FOONLY, INC.		23-DEC-79 15:01	
		CFDACN.DRW (4,41)	
DRAWN BY:	PAGE	OF	NUMBER /
APPROVED BY:	PROJECT:		REV.

CFTA-4
BUG FIXES: (shown in red)
CFTCMA
CFT FCT
CFT I1

FOONLY, INC.		16-MAY-80 02:15	
DRAWN BY:		CFTACN.DRW (5157,4622)	
APPROVED BY:		REV.	
PAGE	OF	NUMBER	
PROJECT:		<i>CFTA-4</i>	
		<i>MASTER COPY</i>

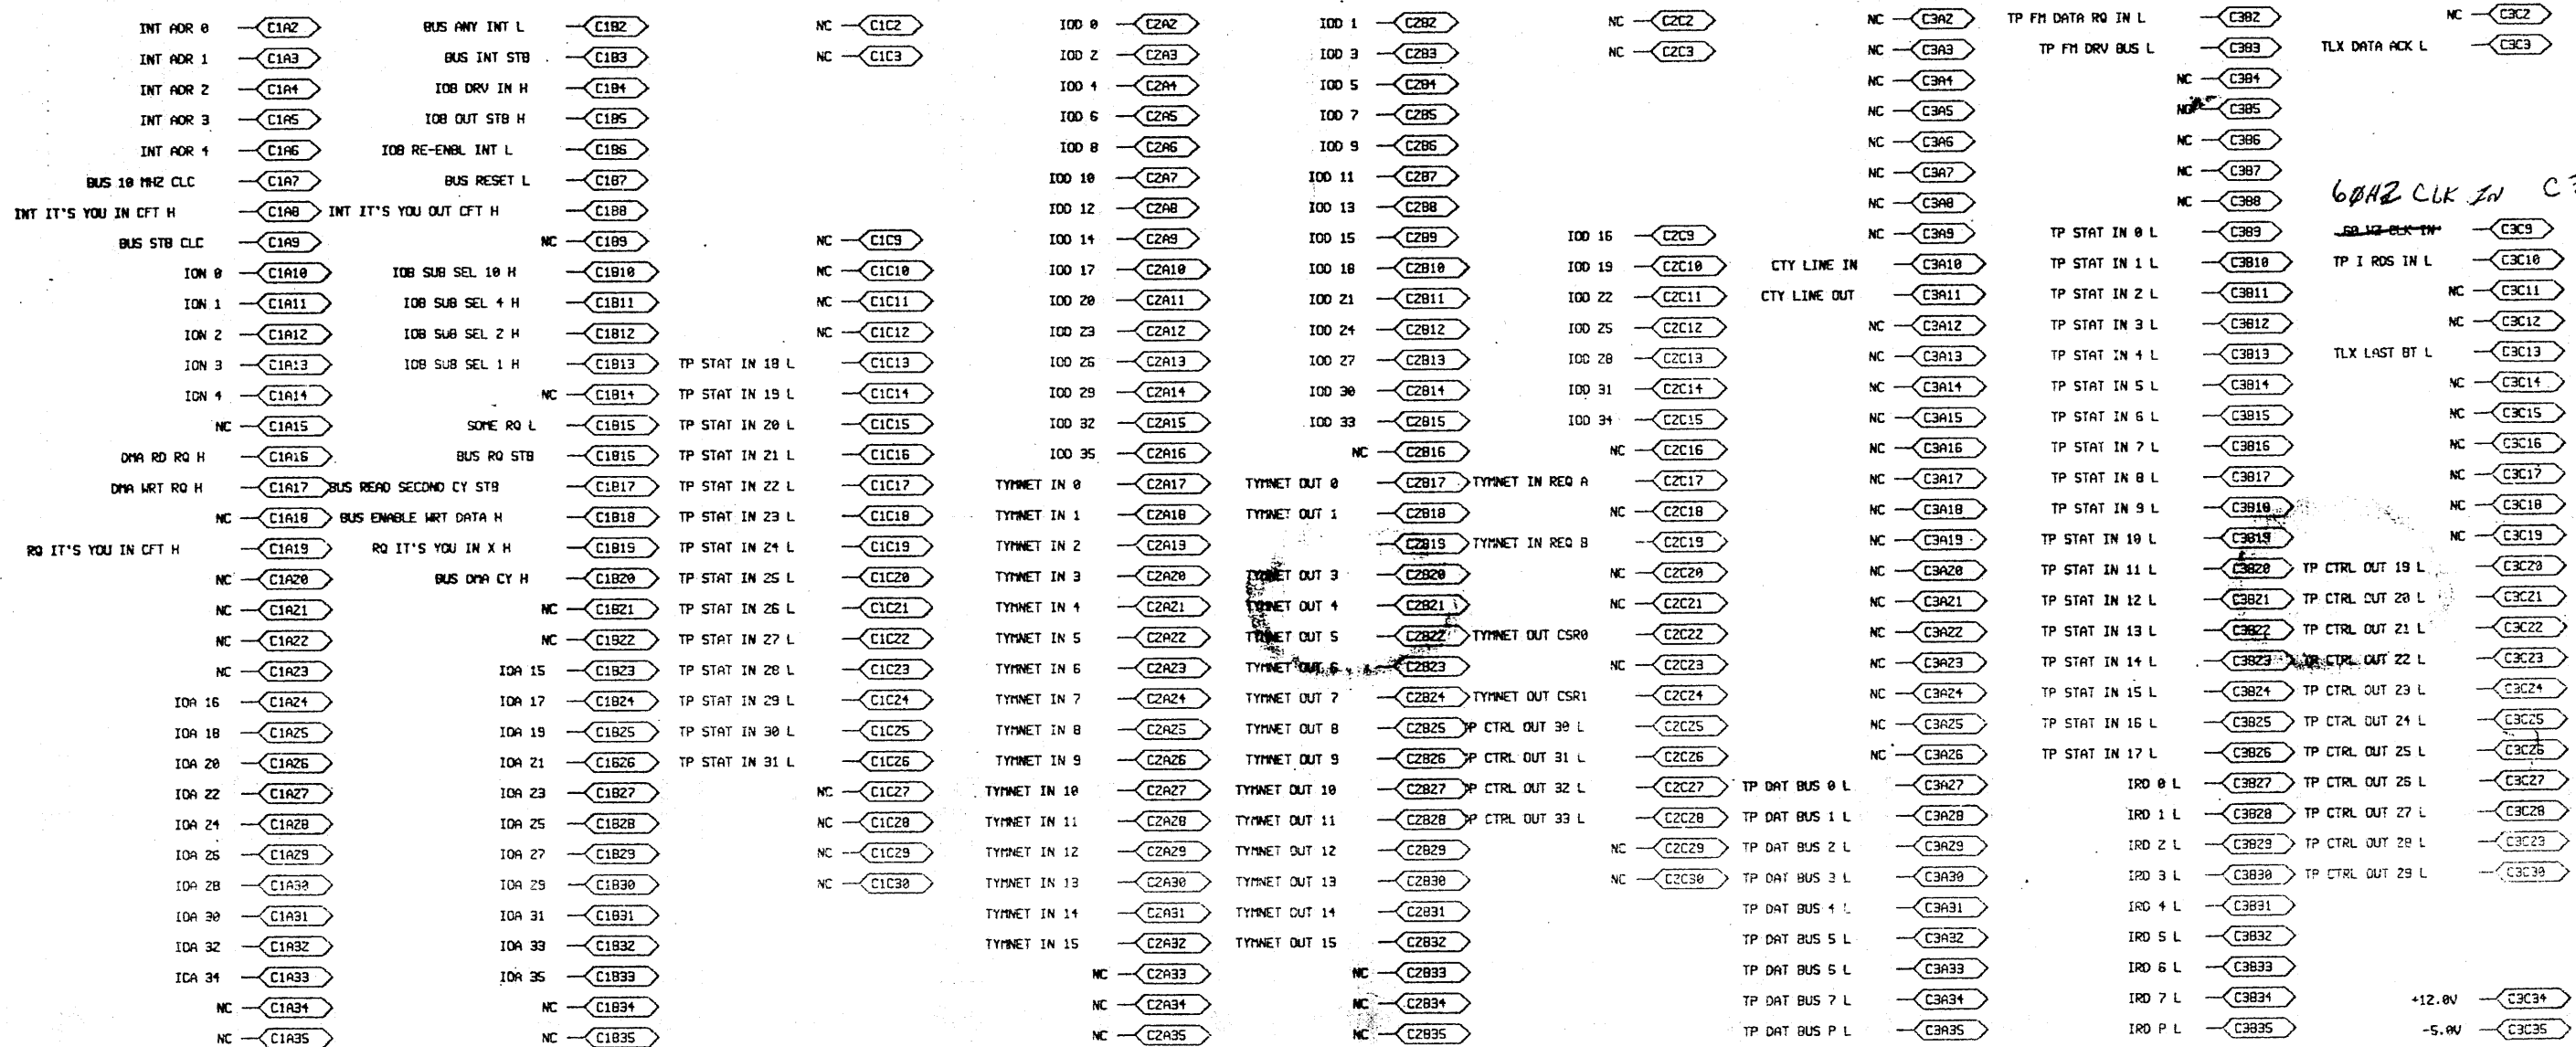
also add:
11-8 to 11-10 (sh 2 wire)
11-19 to 11-21
13-19 to 14-21
C3C35 to 503-2

FOONLY INCORPORATED		19-MAY-80 03:05	
DRAWN BY:		PAGE 1 OF 1	NUMBER
APPROVED BY:		PROJECT: CFTA	REV. 0

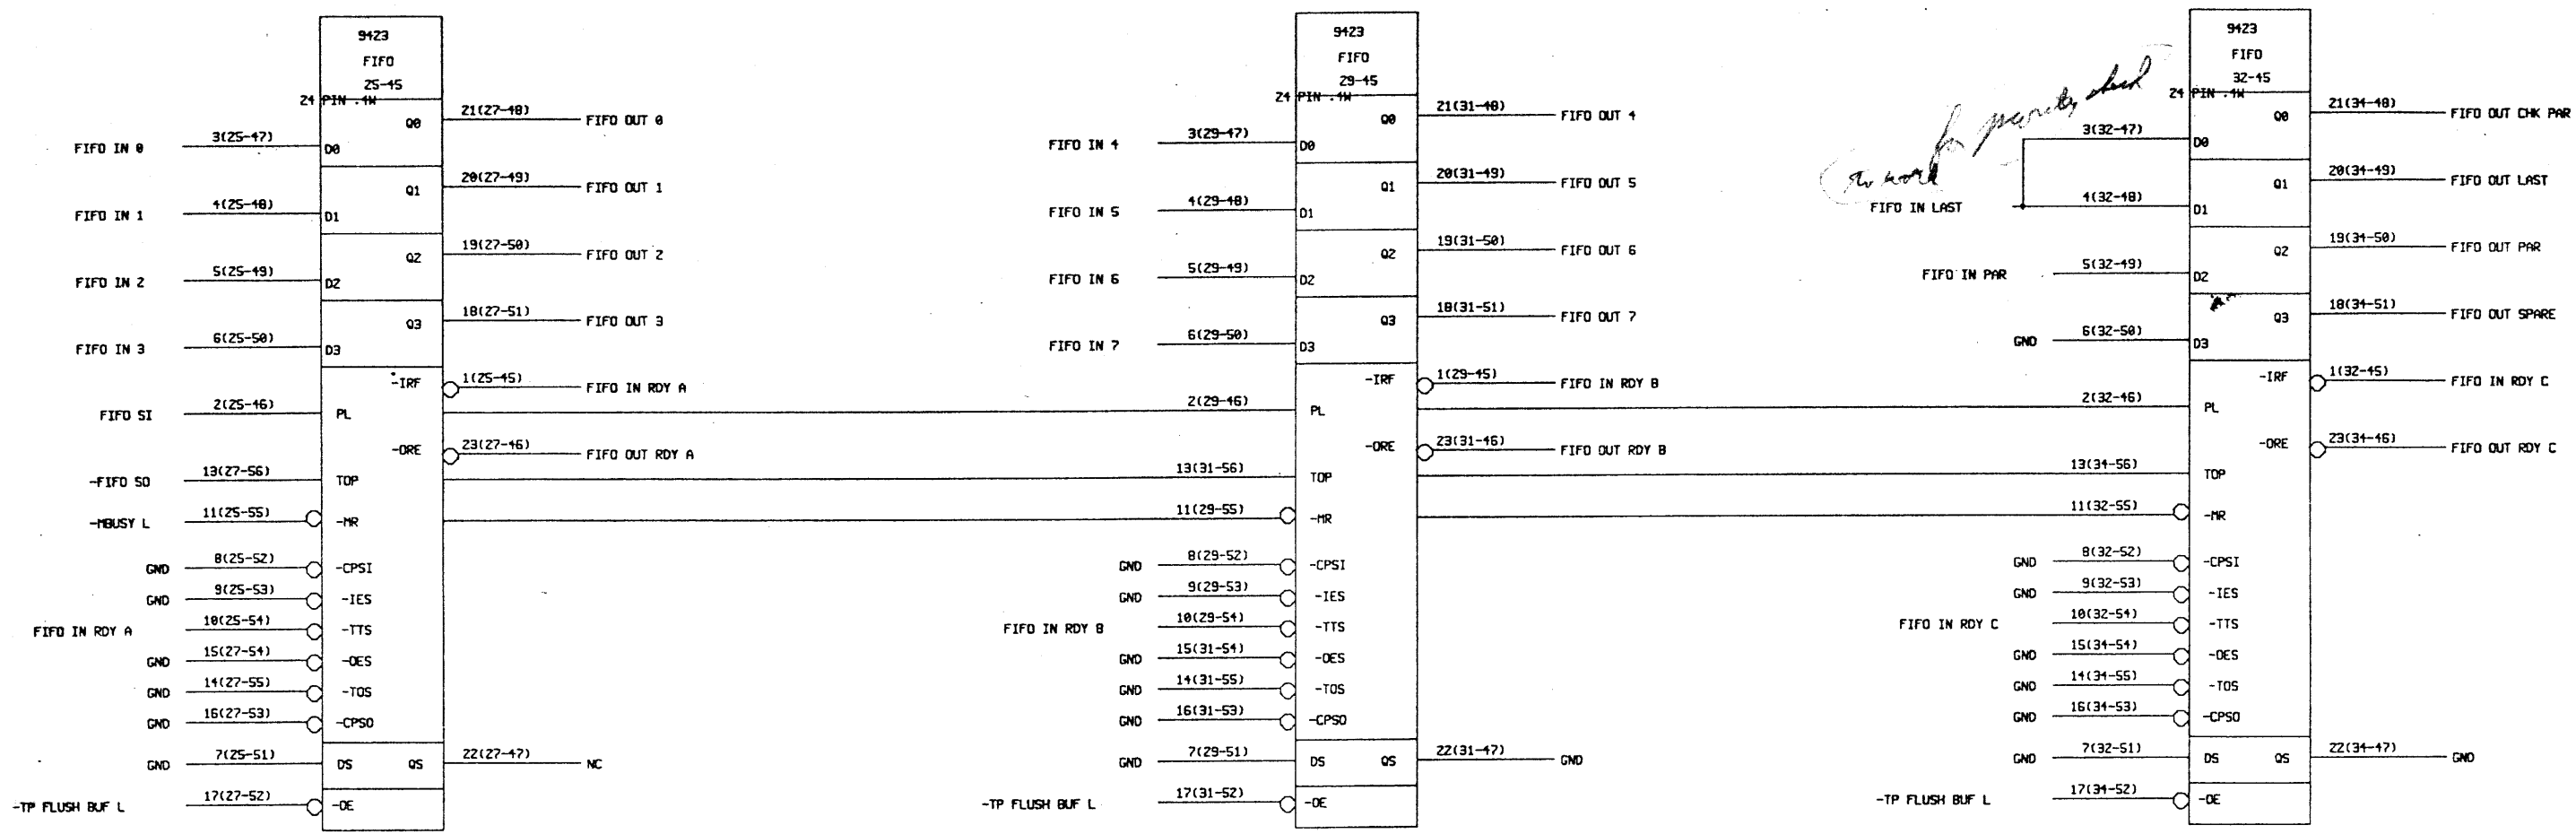
use same FIFO for in and out

FOONLY INCORPORATED		28-DEC-79 05:48	
DRAWN BY:		PAGE 1 OF 1	NUMBER
APPROVED BY:		PROJECT:	REV.
		UFUN, DRW (4, 41)

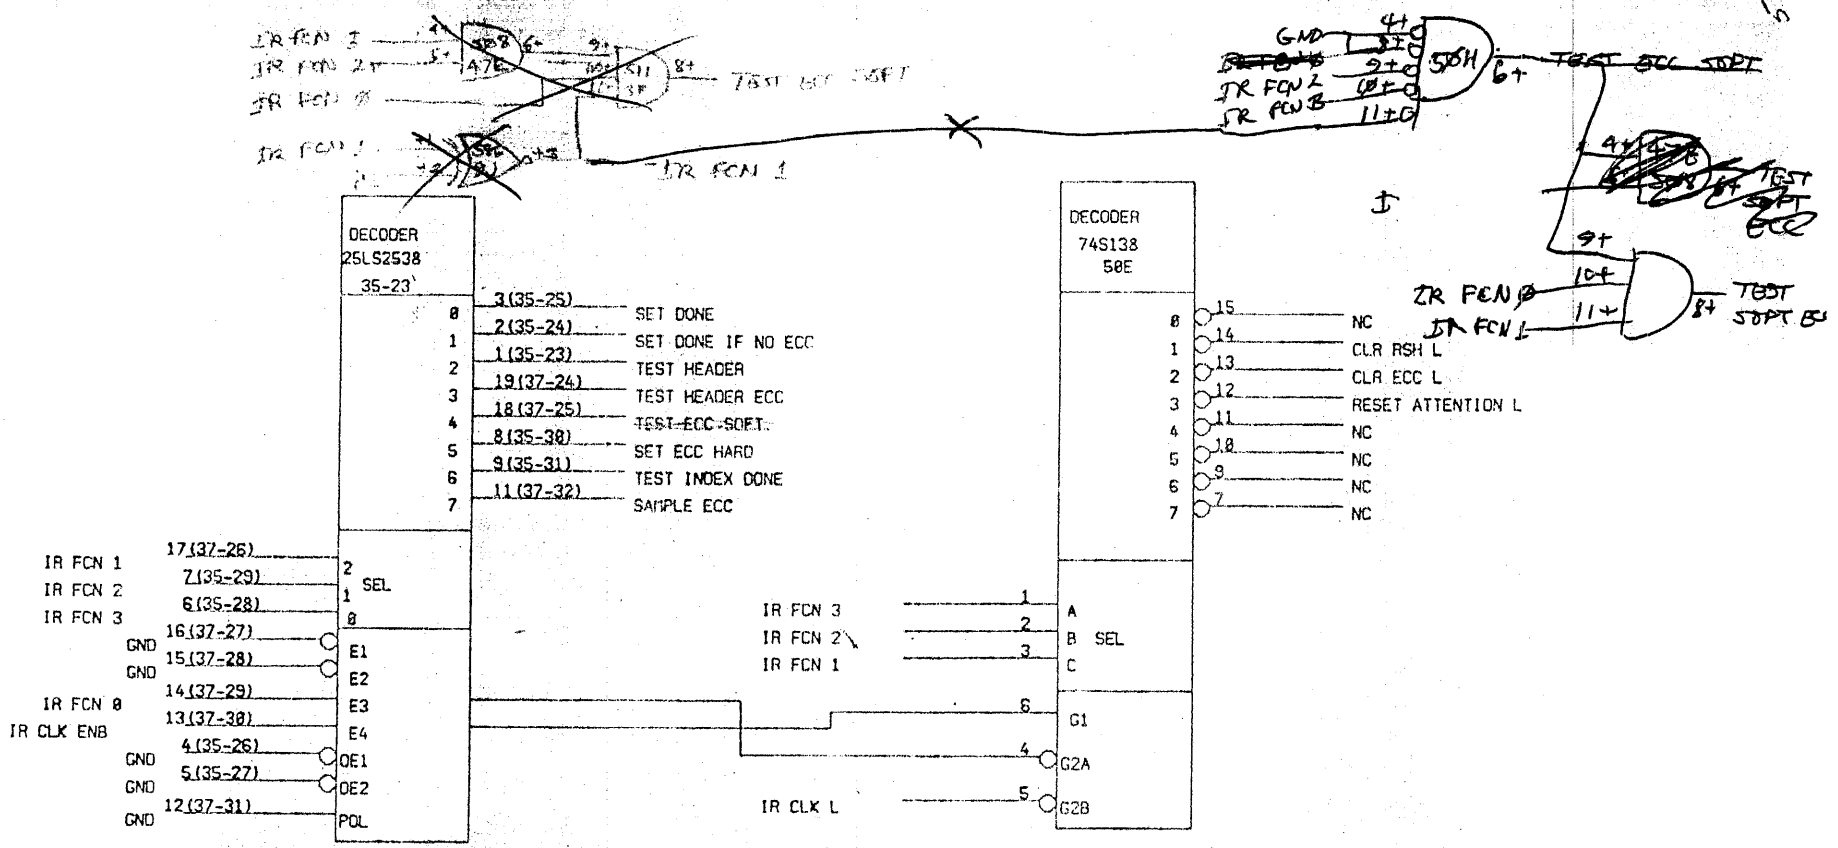
removed :	(37-25)	-	7F10+	TEST ECC SOFT
added :	3F8+	-	7F10+	TEST ECC SOFT
	3F10+	-	(37-29)	IR FCN 0
	3F11+	-	(37-26)	IR FCN 1
	3F9+	-	50H6+	2+3
	50H-8+		50H-4+	GND
	50H-11+		50H-9G	GND
	50H-11+	-	50H-4+	GND
	(35-29)		50H-9+	IR FCN 2
	(35-28)		50H-10+	IR FCN 3
